**CITY OF SEATTLE
ANALYSIS AND DECISION OF THE DIRECTOR OF
THE SEATTLE DEPARTMENT OF CONSTRUCTION AND INSPECTIONS**

Record Number: 3030904-LU
Applicant: Brock Williams
Address of Proposal: 815 9th Ave Seattle

Land Use application to allow an 8-story, 96-unit apartment building. Parking for 8 vehicles proposed. Design Review Guidance conducted under 3030904-EG.*

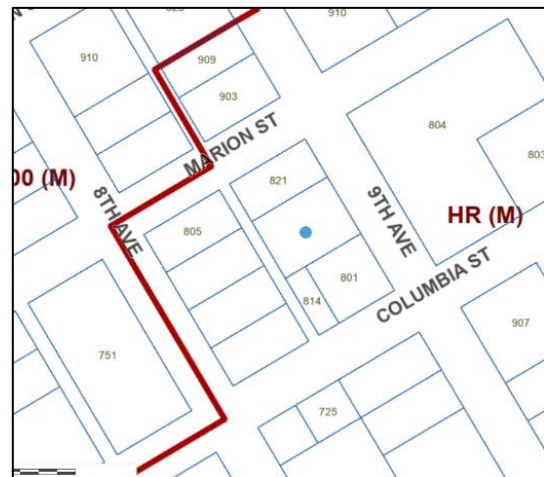
Site Zone: Highrise (M) (HR (M))

Zoning Pattern: (North) HR (M)
(South) HR (M)
(East) HR (M)
(West) HR (M)

The top of this image is North. This map is for illustrative purposes only. In the event of omissions, errors or differences, the documents in SDCI's files will control.
